Redesign diagram

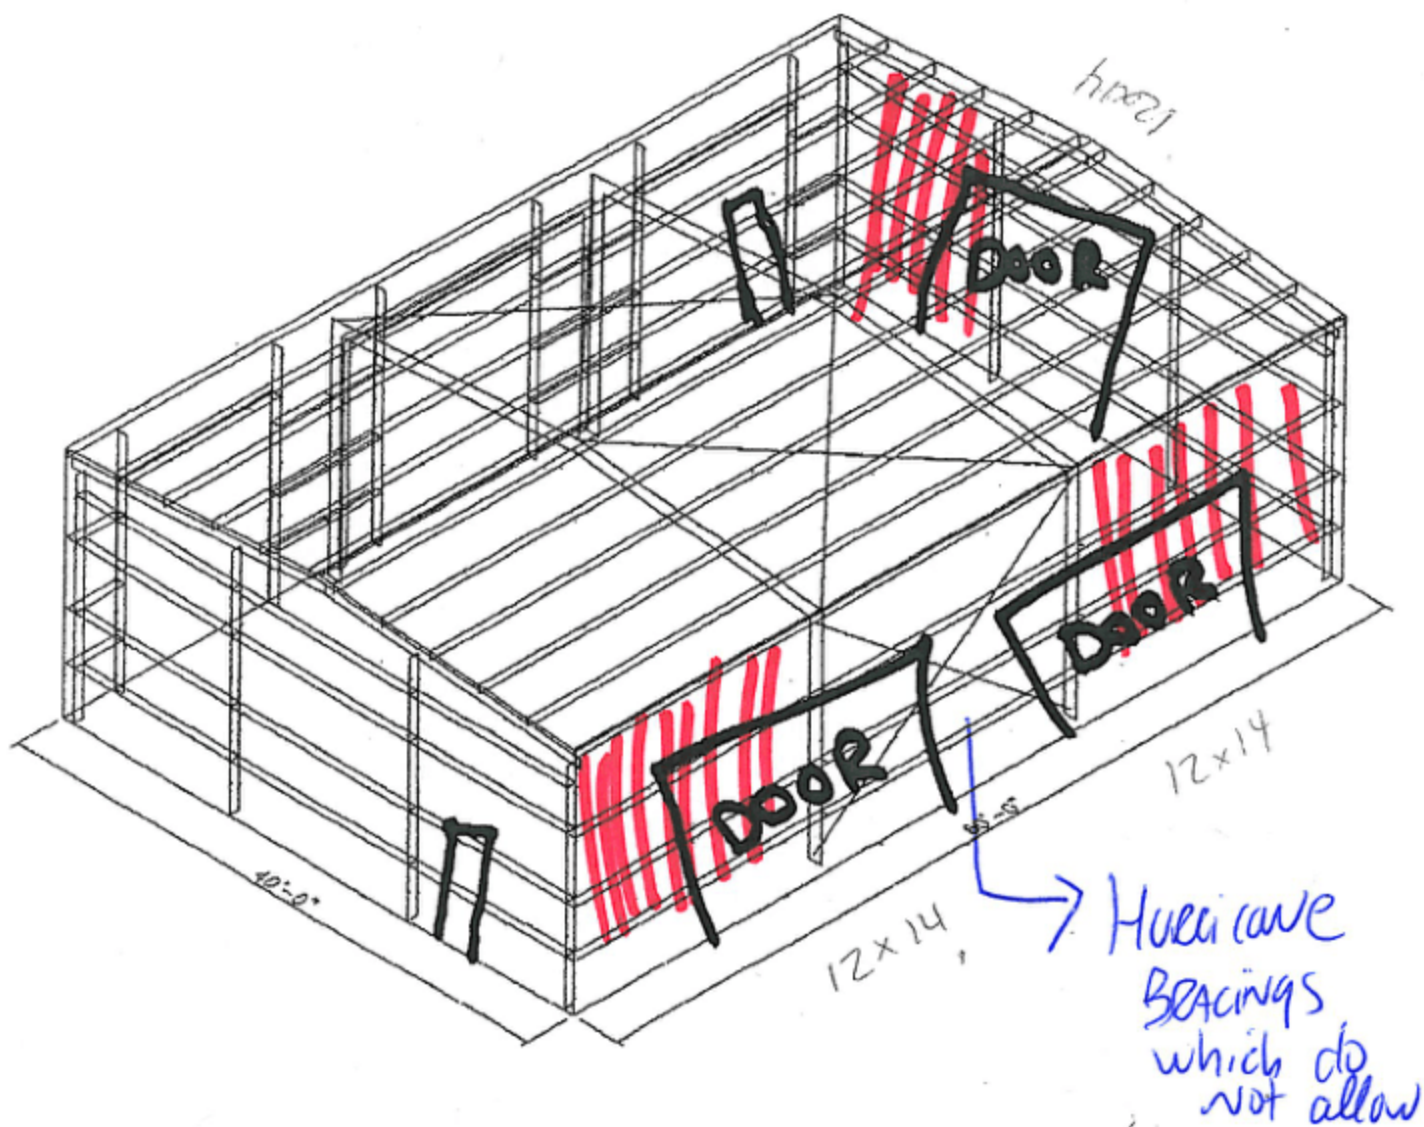
||||| - proposed area for doors

OK 9/25/2012
